Modification Report

Westlink Industry Park - Stage 1 (Modification 6)

7 May 2025 | 2200446

Figure 6 Comparison of Approved and Proposed Lot 3 Office Footprint

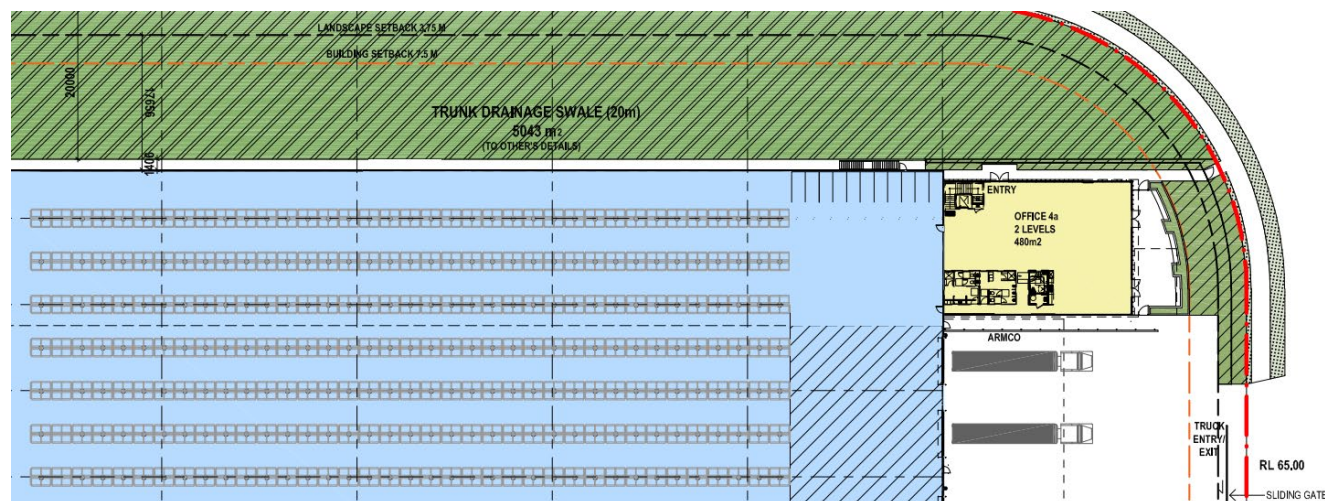
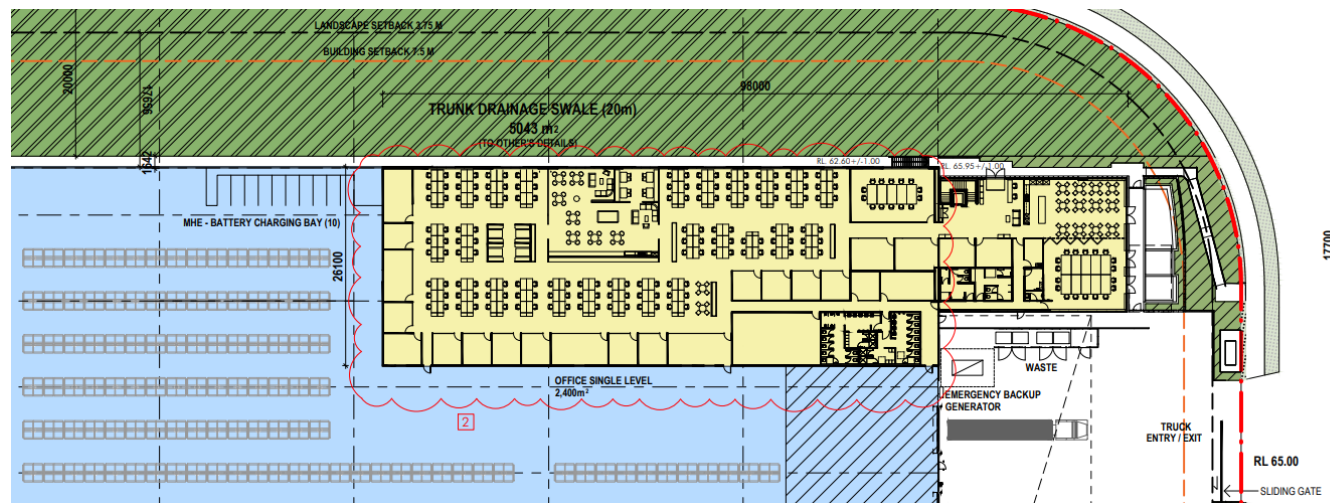
The proposed modifications seek to expand the ancillary office area from 480m² to 2,400m² (+1,920m²) to facilitate the operational requirements of the future customer. It will support the provision of larger workstations, enhanced recreational and break areas, and improved staff amenities.

The proposed changes to the ancillary office area includes the conversion of the north-eastern corner of the warehouse to an expanded single-level ancillary office area. The expanded office area includes a large open office area with dedicated office areas and meeting rooms throughout, as well as a large amount of staff amenities including large lunch and collaboration areas and a gym. Further, natural light will be provided through windows to the north and south within the warehouse. A comparative illustration of the approved and proposed office space footprints and layout is provided in **Figure 6** below.

Figure 7 Comparison of Approved and Proposed Warehouse 3 Northern Elevation

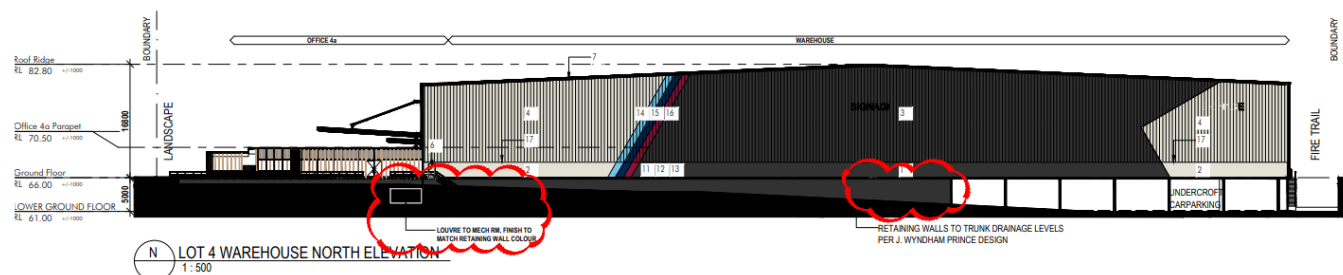
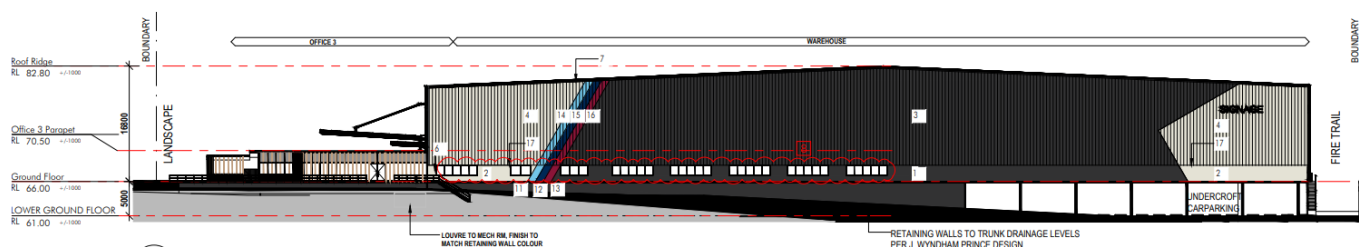
The proposed changes associated with the ancillary office area also include the incorporation of windows along the associated area of the northern elevation. It will enable natural light within the enlarged office area with views of the naturalised trunk drainage channel to be delivered along the northern boundary of Lot 3. A comparative illustration of the approved and proposed northern elevation is provided in **Figure 7** below.

Figure 8 Comparison of Approved and Proposed Warehouse 3 Site Plan – Dock Office

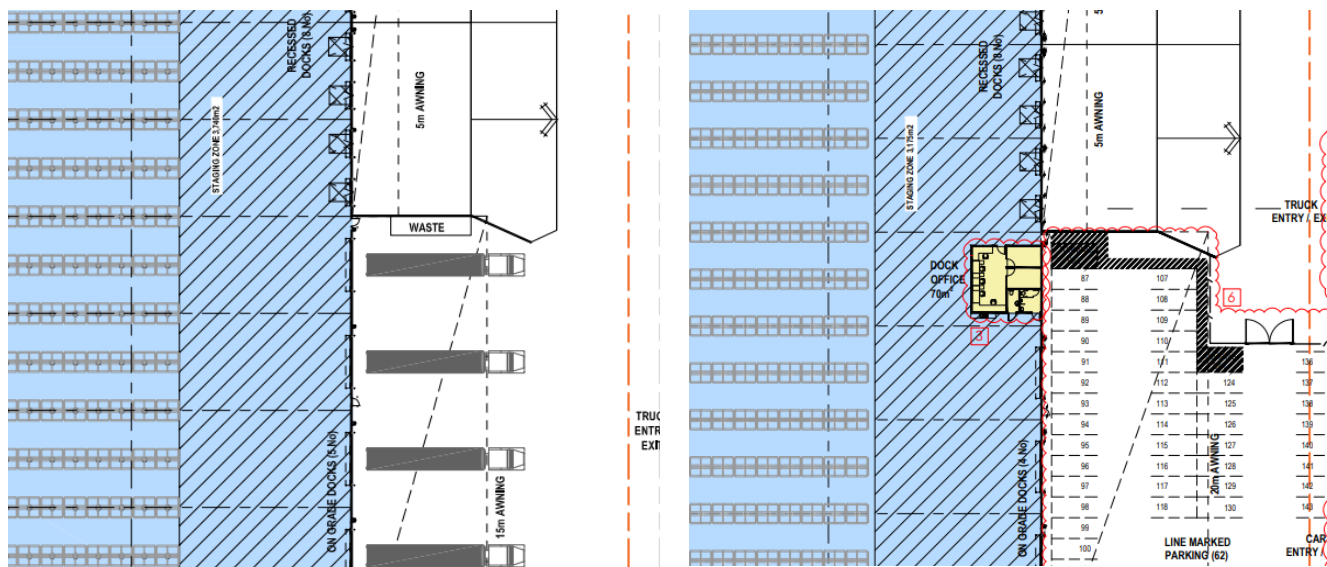
The proposed modifications include the addition of a dock office, as requested by the future customer, to support operations on the loading dock. It includes 70m² of ancillary office GFA and will adjoin the eastern warehouse wall, resulting in the removal of one (1) roller shutter door and an increase in overall GFA as it replaces area previously dictated as loading zone area. A comparative illustration of the approved and proposed Lot 3 Site Plan is provided in **Figure 8** below.

Figure 9 Comparison of Approved and Proposed Warehouse 3 Site Plan – Car Parking and Hardstand

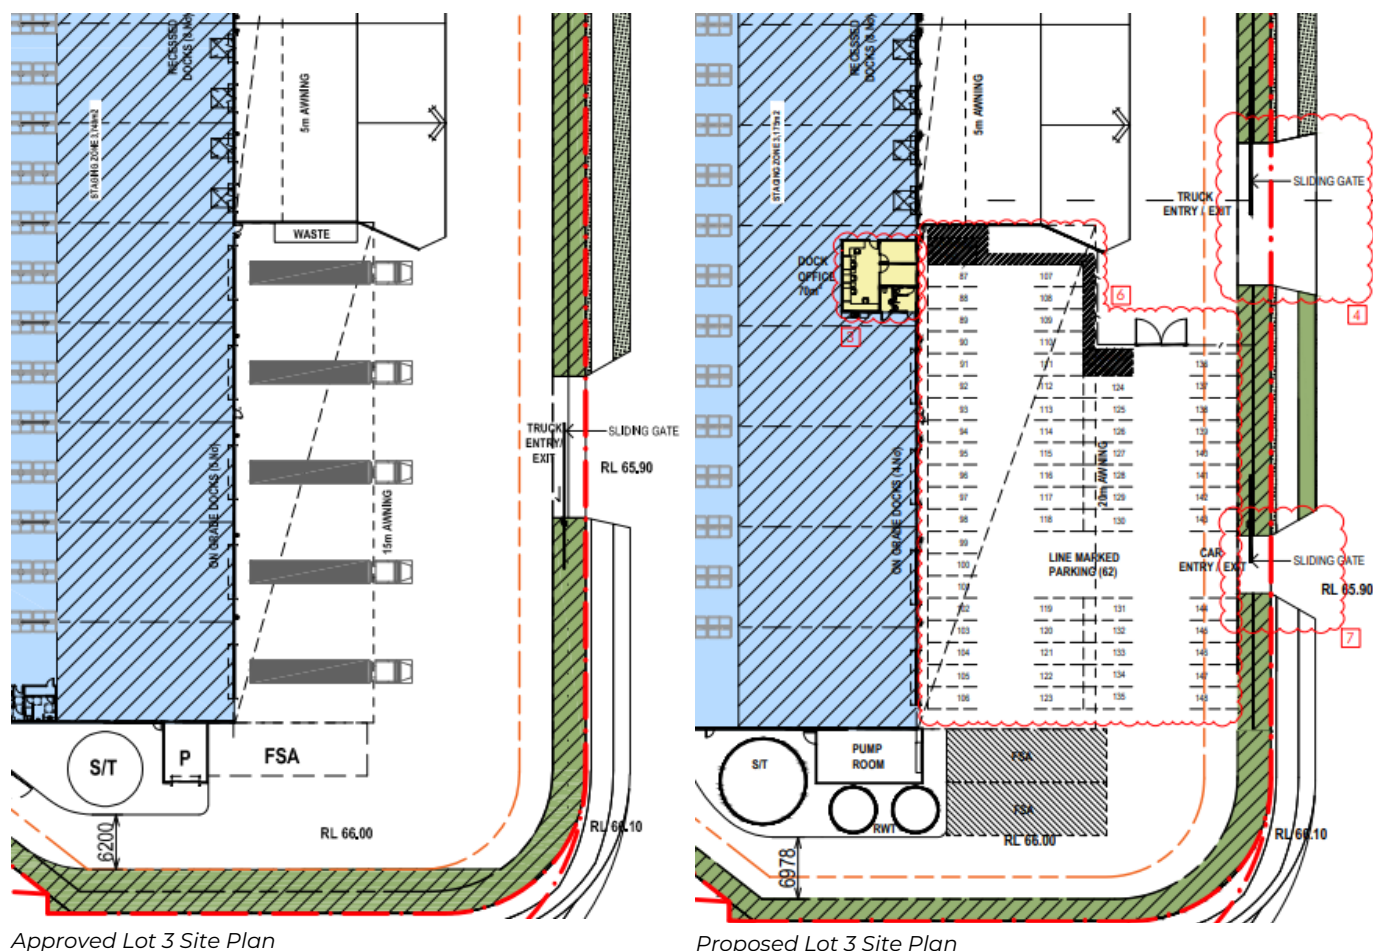
In order to support the additional ancillary office space and the operations of the future customer, the car parking provision is proposed to increase from 85 to 146 (+ 61) car parking spaces. The additional car parking spaces are proposed to be located along the southern portion of the Lot 3 hardstand area, with the area proposed to be converted from a heavy vehicle loading area to a dedicated light vehicle area (refer to **Figure 9**).

A new light vehicle entry/exit driveway is proposed adjacent to the southern portion of the hardstand to support access to the new car parking area. In addition, the approved southern heavy vehicle driveway is proposed to be moved to the north to enable heavy vehicle access that is not impeded by the new car park area. The proposed changes to the driveways has been incorporated onto the amended On-Lot Civil Drawings prepared by AT&L and included at **Appendix E**. As a result of the proposed modifications, minor changes are proposed to the approved landscape design, as depicted in the amended Landscape Drawings prepared by Site Image at **Appendix D**.

A comparative illustration of the approved and proposed southern hardstand and driveway design is presented in **Figure 9** below.

Figure 10 Pedestrian Access Plan

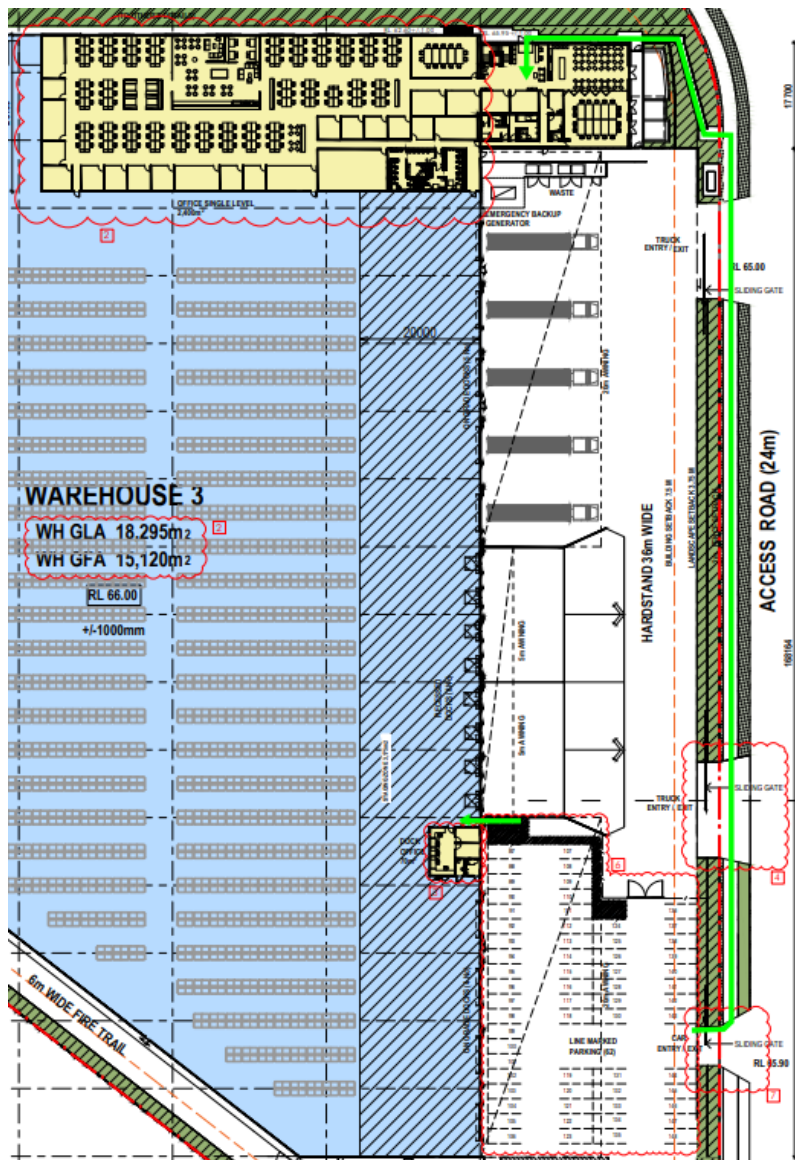
It includes supporting safety features such as fencing to separate the car parking area from the heavy vehicle area and pedestrian access ways to support safe pedestrian access. Pedestrian access from the car parking is available directly to the warehouse adjacent to the dock office, or to the office via the pedestrian pathway along the Access Road to the east, as illustrated in **Figure 10**.
